# Technical BULLETIN

## SAFETY RECALL

### CERTAIN 2015 ~ 2018 SR400 MOTORCYCLES FACTORY MODIFICATION CAMPAIGN – Oil Leak from Flare Nut on Oil Hose

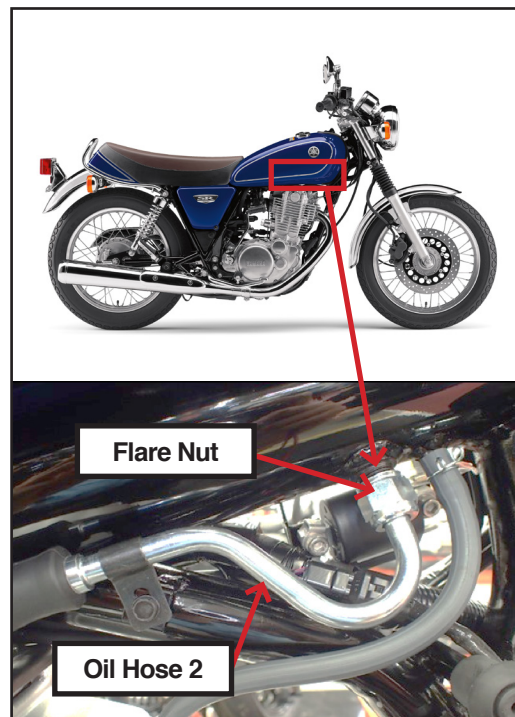
Yamaha Motor Corporation, U.S.A. has decided that a defect which relates to motor vehicle safety exists in certain 2015 through 2018 SR400 motorcycles. In affected motorcycles, it is possible for oil to leak from an oil hose fitting (flare nut) under the fuel tank on the right side. If this occurs, the oil could get on the rear tire, causing slipping, which could result in loss of control and a crash with injury or death.

To correct this defect, Yamaha is initiating a Factory Modification Campaign. Affected units must have the oil hose fitting inspected and tightened to specification, unless oil leakage has already occurred, in which case the oil hose must be replaced with a new one.

**Example**

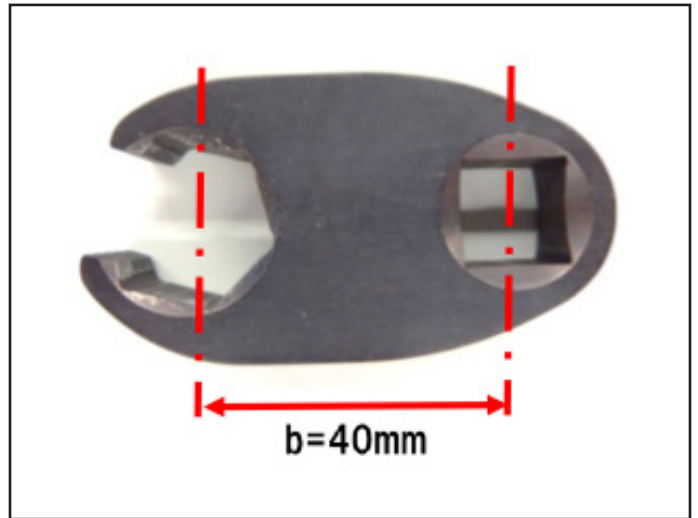
You must calculate the torque specification for the torque wrench you are using with the special flare nut wrench to avoid damage to the oil hose or risk of oil leaking.

The total tool length will depend on the type of the torque wrench used. The set torque value of the torque wrench depends on the total tool length. Calculate the set torque value using the formula below.

$$\frac{a}{(a + b)} \times 50\text{Nm (5.0m-kgf)} = \text{Set torque value}$$

a=260mm b=40mm

$$\frac{260}{260 + 40} \times 50\text{Nm (5.0m-kgf)} = 43.3\text{Nm}$$

In this example, set the torque wrench to 43 Nm (4.3 m-kgf, 32 lb-ft)

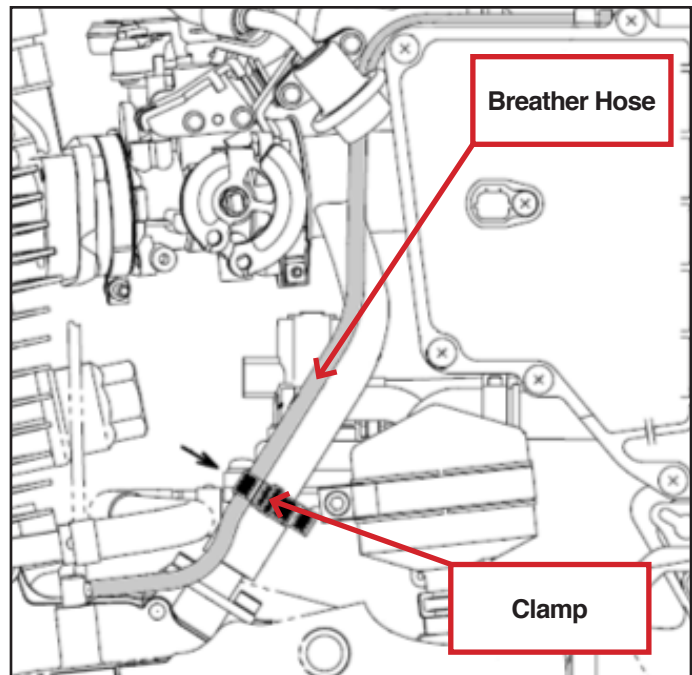
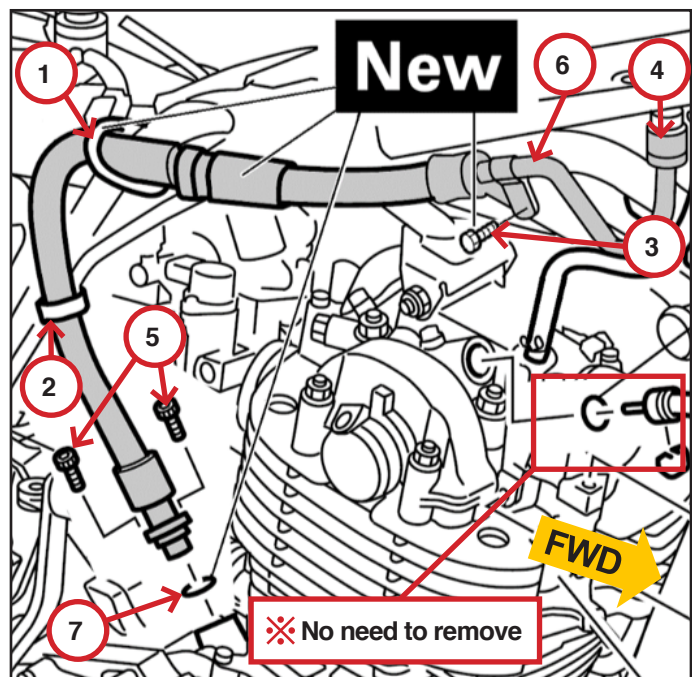
If engine oil leakage is found, replace oil hose 2 as follows.

1. Remove the breather hose clamp.

2. Remove:

- Band "1" (discard, will not be reused)
- Clamp "2"
- Clamp bolt "3" (discard, will not be reused)

3. Loosen flare nut "4."

4. Pull the oil hose 2 "6" up in order to return the engine oil in the oil hose 2 to the engine.

5. Remove the two bolts "5."

6. Remove oil hose 2 "6" and O-ring "7" (they will not be reused).
